Application No. 10/656,324
AMENDMENT C dated April 3, 2006
Reply to Office Action of November 2, 2005

REMARKS

FIG. 1

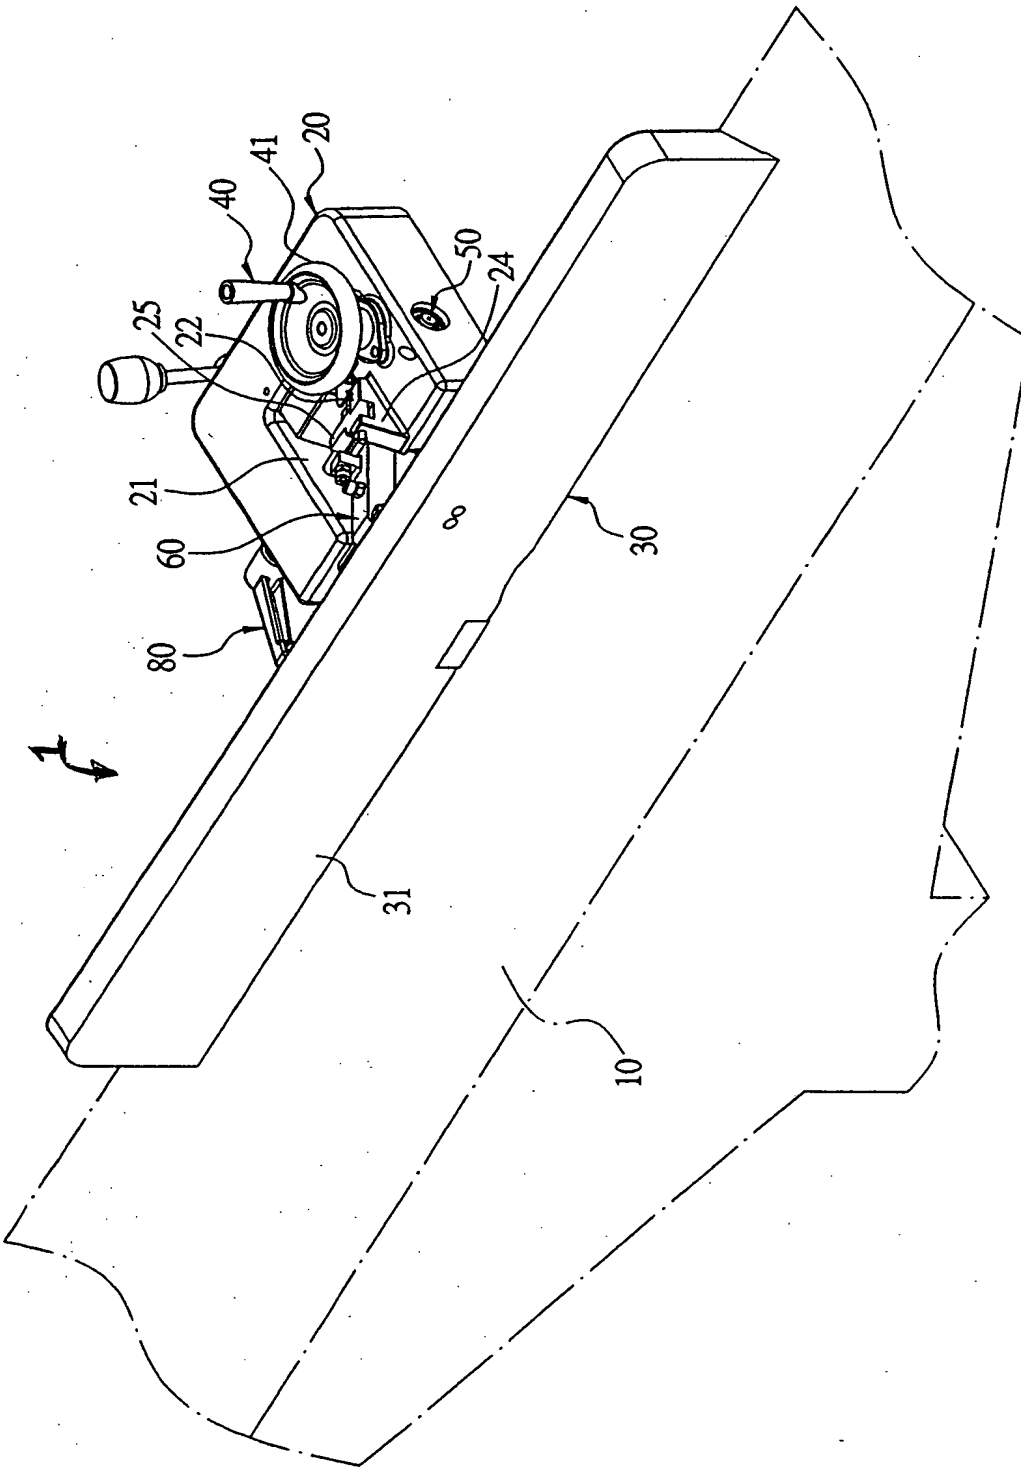
The drawings were objected to under 37 C.F.R. §1.83(a) for failing to show each and every feature of the invention specified in the claims. More particularly, the drawings were objected to because they fail to show a "planar" and a "base," as recited in previously submitted claim 21. Applicants submit that Fig. 1 has been amended to include reference numeral "1" and paragraph 0015 of the specification has been amended to clarify that reference numeral "1" pertains to the "planer" discussed throughout the application. Claim 21 has also been amended to eliminate the objectionable "base" language. Support for these amendments can be found throughout the application, and in particular in paragraphs 0001 and 0004 to 0015, the abstract and original claims of the application, and in drawing Fig. 1.

Attachments: Replacement Drawings sheets 1-8; and
Annotated sheet showing the change made to Fig. 1.
